November 2, 2012

Re: **EPA Comments Dated 10/22/12**
Vapor Intrusion Characterization Work Plan (Revision 1.0)
Walter Coke
3500 35th Avenue North
Birmingham, Jefferson County, Alabama
USEPA ID No. ALD 000 828 848
Terracon Project No. E1127095

FIGURE 4
TAX MAP
City of Birmingham Mapping
Scale as Shown'

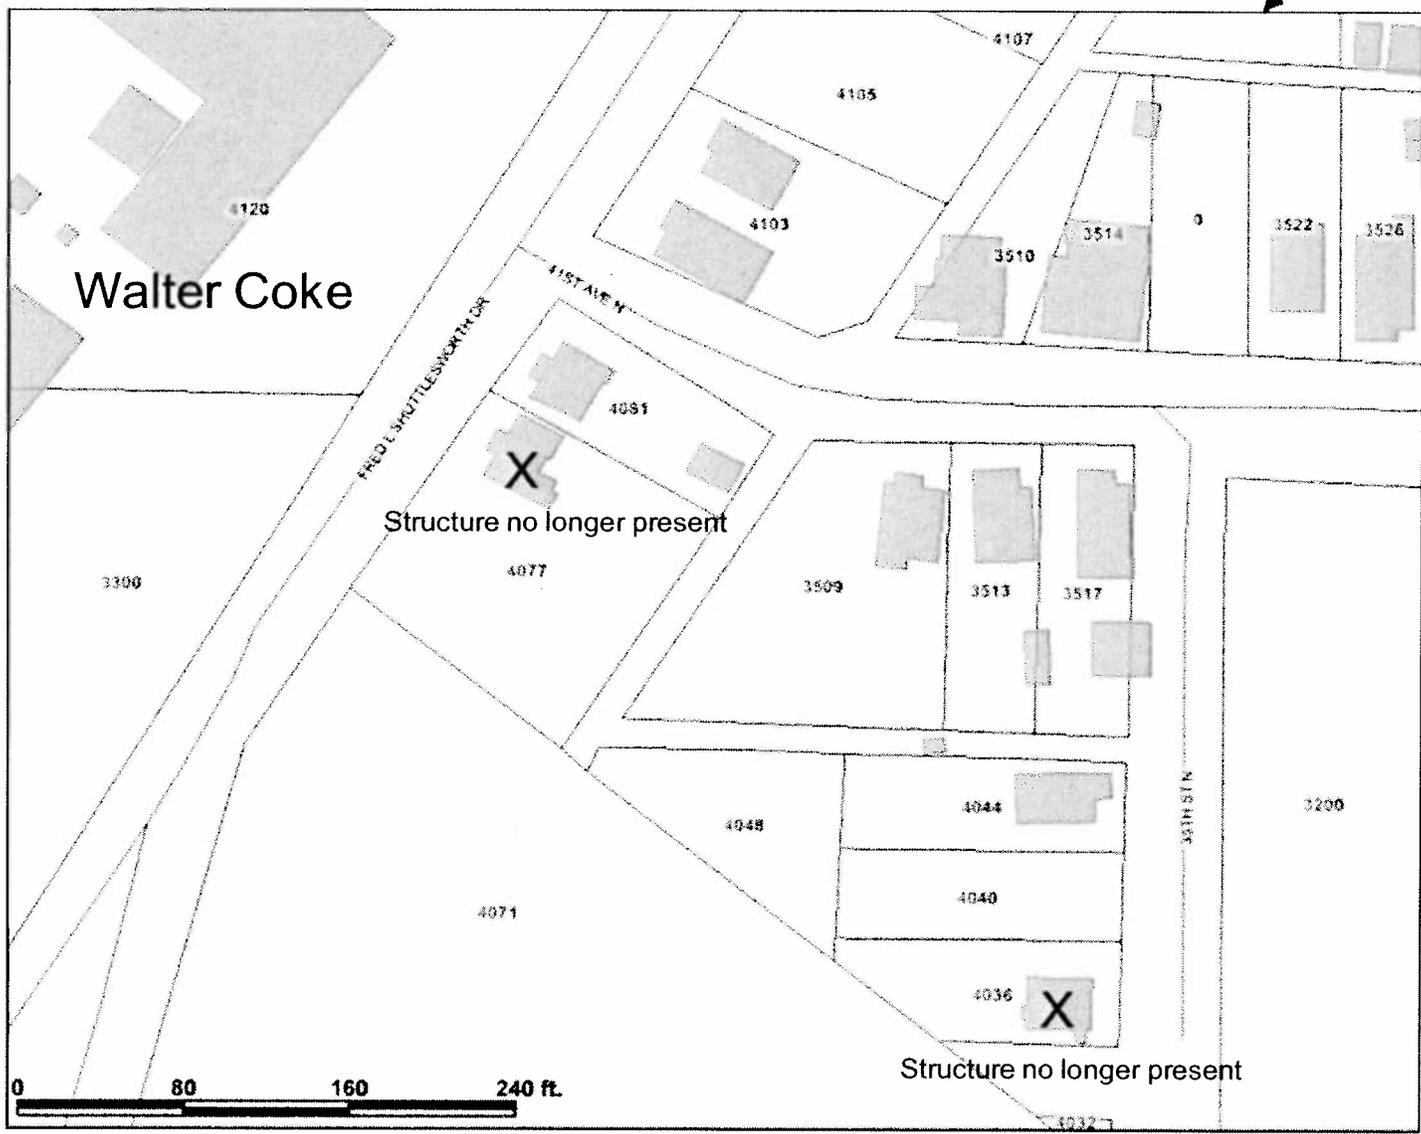
Please expand the study area to include the four additional homes on 41st Avenue North, between Shuttlesworth Drive and 35th Street North, as discussed above, and update Figure 5 and Appendix B accordingly.

Section 2.1 Proposed Study Area has been modified. In addition, all of the figures have been modified and Figure 3 incorporates the new soil vapor sampling locations. Appendix B has been modified and Figure 4 has been added and is a tax map illustrating the properties included in Appendix B.
